From: Howe, Jeremy (EGLE)
Sent: Friday, August 20, 2021 3:24 PM
To: Puite, Tammie (EGLE)
Subject: FW: Grayling Generating Station, LP - VN Second Response
Attachments: GGS_VN_FLOW CEMS_August_SubmittalwAttachments_Appedicies_Signature.pdf

**RE: Response to Violation Notices issued June 18, 2021 and July 28, 2021
Grayling Generating Station Limited Partnership [SRN: N2388]
Failure to Continuously Monitor Emissions Utilizing Flow CEMS**

Grayling Generating Station, LP Technical Memorandum in Response to Violation Notices

Figure 2-4. Source Layout, Monitoring Probe and Test Port Locations (Figure from the time of installation. Note that stack diameter is based on the 94” design)

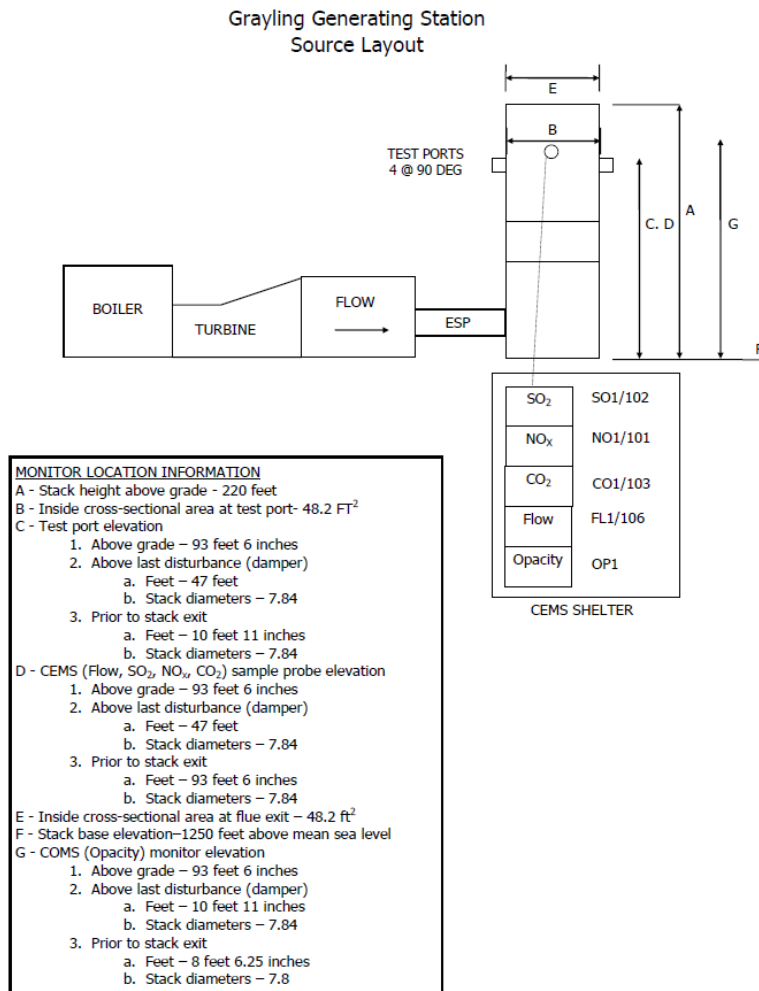
During an August 5, 2021 teleconference with the EPA, Mr. Charles Frushour stated that he thought Appendix A of Part 75 contained guidance for the siting of the sample path/location relative to the stack or duct wall. However, after having reviewed 40 CFR Part 75, Appendix A in detail, we conclude any provisions relating to the distance between the measurement point/path and the stack or duct walls only pertain to gas monitors, not flow monitors. Thus, we are not aware of any specific requirement for flow monitors regarding the distance between the measurement location and stack or duct walls.

The location of the flow monitor is shown in the Source Layout presented as Figure 2-4. As shown, the flow probe is located in a position that meets EPA Part 60, Appendix A, Method 1 citing criteria with regard to upstream and downstream disturbances. Also, the performance specification was met, as documented in the recertification submittal and

Of specific note is the last sentence of the regulatory excerpt which plainly states, regardless of installation location, if the device meets performance specifications, then the monitor location is acceptable.

Figure 2-5. SICK Installation Guidance

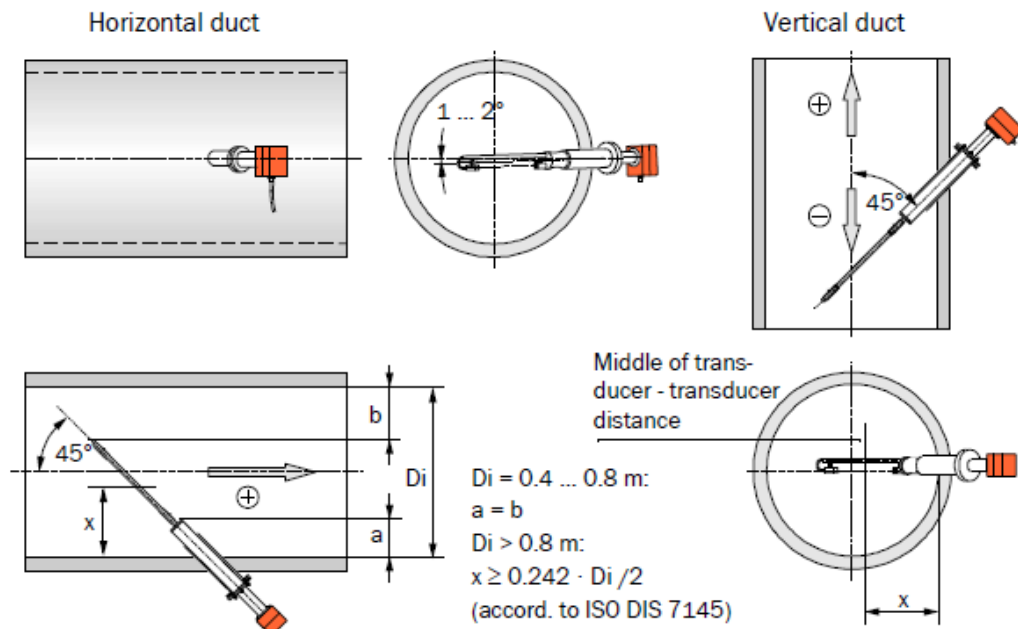
Based upon physical measurements of the probe and test port during the 2021 RATA, the flow CEMS measurement path sits at approximately 4.6” to 12.0” into the stack perpendicular to the stack wall. Figure 2-5 is an excerpt from the SICK Operating Instructions for the flow monitor. Per SICK’s written guidance, the distance between the center point of the flow measurement path and the stack wall in vertical configurations should be equal to 0.242 times the diameter divided by 2. For the GGS installation, the preceding equates to 11.1” from the stack wall [$0.242 \cdot 92'' / 2$].

It is our understanding that SICK offers the same model of flow CEMS with a probe that is 20 centimeters longer than the current probe. As such, the longer probe would be expected to result in a path center point that is 13.98” from the stack wall (the measurement path, perpendicular to the stack wall, would be at 10.2” to 17.6”). After reviewing this concept with SICK, we received an email reply from their technical engineering department which states:

Figure 2-6 Monthly Average CO₂ Concentrations Versus Time at the Low Operating Level

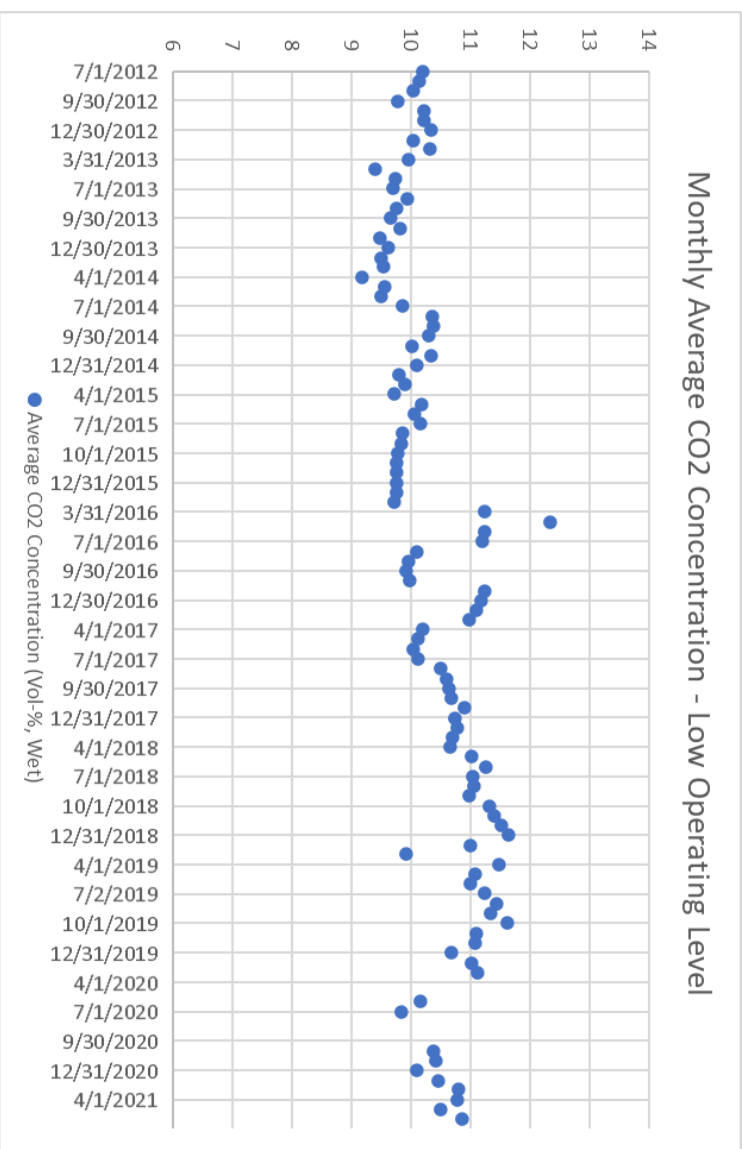
Figure 2-6 does show an upward trend in CO₂ concentrations in the last 5 years as compared to the previous five years. This would correlate to a reduction in boiler exhaust gas flow rates. It is not currently known if the trend in CO₂ concentrations is driven by operator induced changes in excess air levels, or a reduction in overall air in-leakage surrounding the 2017 outage in which the current flow CEMS was installed.

Figure 2-7. EGL's "Flow to Load Chart" as contained in the VN

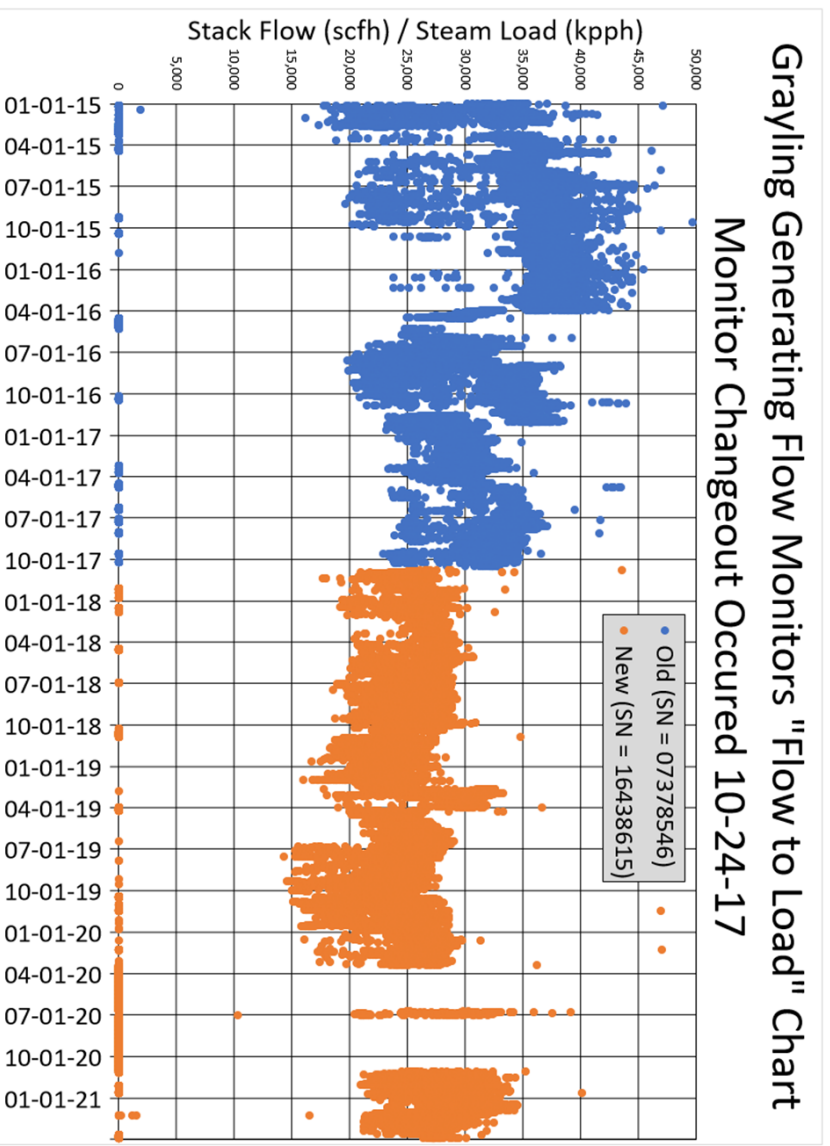
As support of their assertion that something must be wrong with the Grayling flow CEMS, EGLE provided the “Flow to Load” chart for the period 01/01/2015 through 03/31/2021 within their June 18, 2021 Violation Notice. EGLE’s discussion focused on the data before and after the 2017 flow monitor changeout, noting a divergence following the 2017 flow monitor changeout. To our knowledge, EGLE’s Flow to Load chart, as shown in Figure 2-7 below, is based upon all available flow data, regardless of boiler operating level.

The preceding type of approach is contrary to EPA's own flow-to-load (FTL) quarterly quality assurance (QA) test in that there is no segregation of data based upon operating level. Likely in recognition that excess air levels can vary significantly across the operating range for a given unit (and thereby influence the relationship between exhaust flow rates and load), EPA's FTL test relies upon a baseline FTL record which is constructed following each successful flow RATA for each operating level (Low, Mid and High) designated as normal in the Part 75 monitoring plan. When assessing the FTL result at a given operating level, the EPA further excludes data in which the hourly average load differs by more than +/- 10% relative to the average load associated with the baseline value. The prescribed way to evaluate flow to load is by normalizing the data within a load bin, as the regulation cites in Part 75, Appendix B, 2.2.5(a)(4):

Figure 2-8 presents flow-to-load ratios for the period 07/01/2012 through 06/30/2021 based upon all valid hourly flow data associated with the low operating level only, as that is the main operating mode for GGS. When the flow data is segregated by operating level, there is less variance in the resulting flow to load ratios as compared to the chart prepared by EGLE. Further, when the data set is extended further back in time (in this case, to 07/01/2012 as opposed to 01/01/2015), observe that the 2015 and 2016 flow to ratio ratios were generally higher than those in preceding years.

Figure 2-8. Exhaust Flow to Steam Flow Ratios for all Valid Data in the Low Operating Level

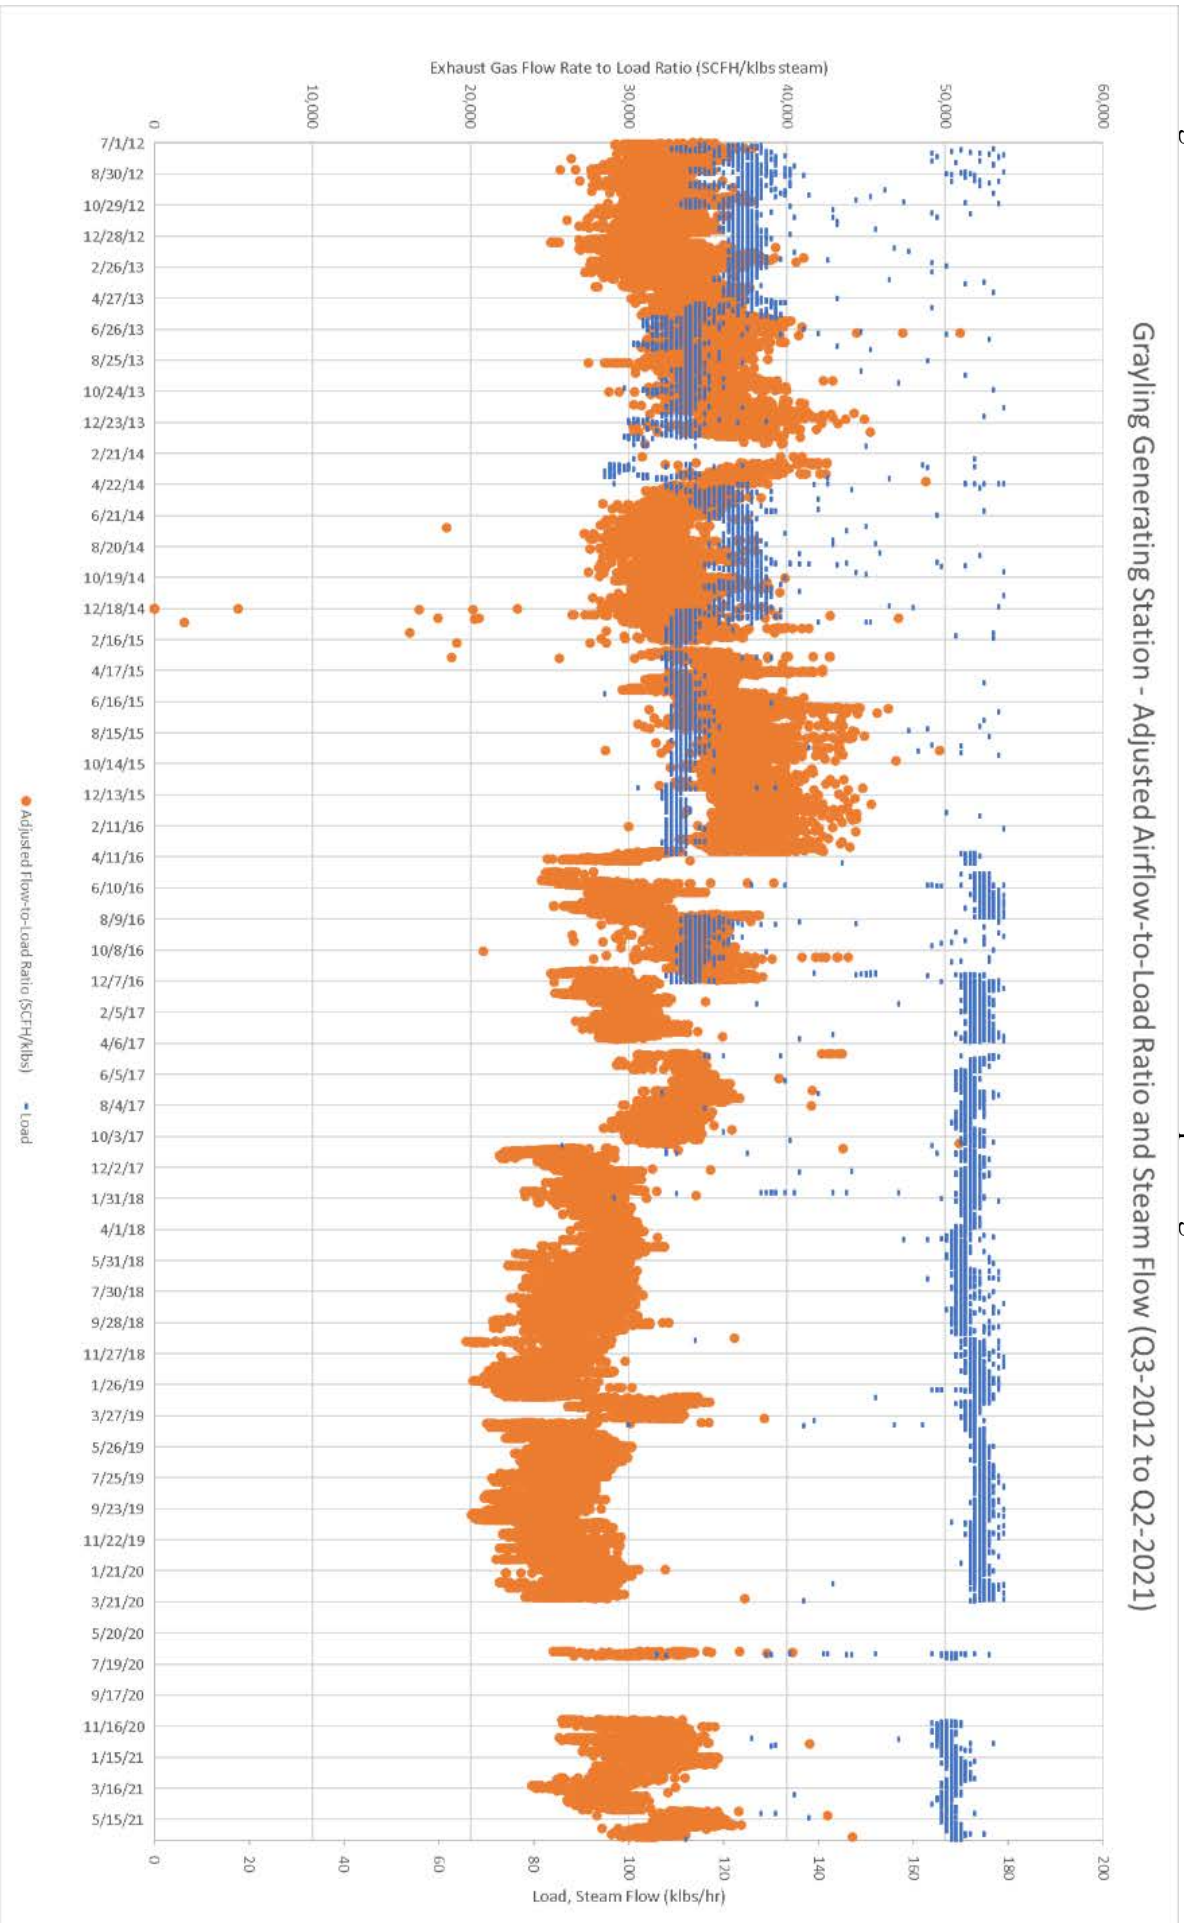
Please note that there are several locations in Figure 2-8 that show a “step change” in flow. These changes are likely more common to biomass fuel boilers due to inherent variability in fuel characteristics. In GGS’s opinion, this figure also provides visual clarity on how variable flow can be in biomass type boilers across their load range, while balancing fuel quality (moisture, particle size, BTU content), which can have a significant impact on managing combustion air, as well as to highlight the operational shift previously discussed.
